Certificate of Appropriateness

2163 N. SHERMAN BL. Sherman Boulevard HD

PTS ID 114674 COA: rebuild jump porch, other repairs

Current conditions.

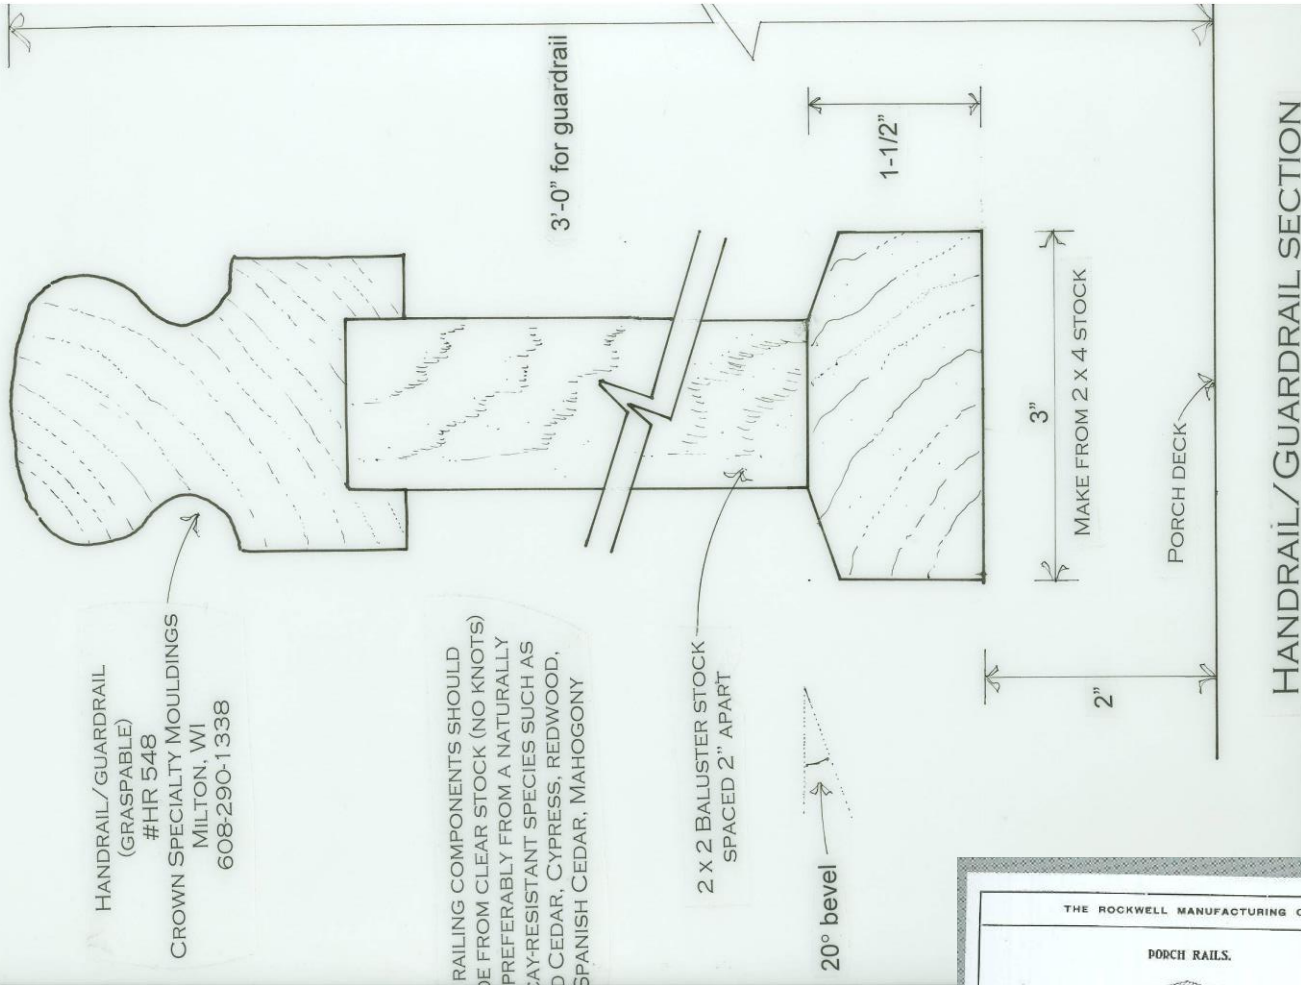
Match this baluster size and spacing. Trim balcony joists to hide as shown with slight overhang of the deck on all three sides. Present posts on balcony may remain.
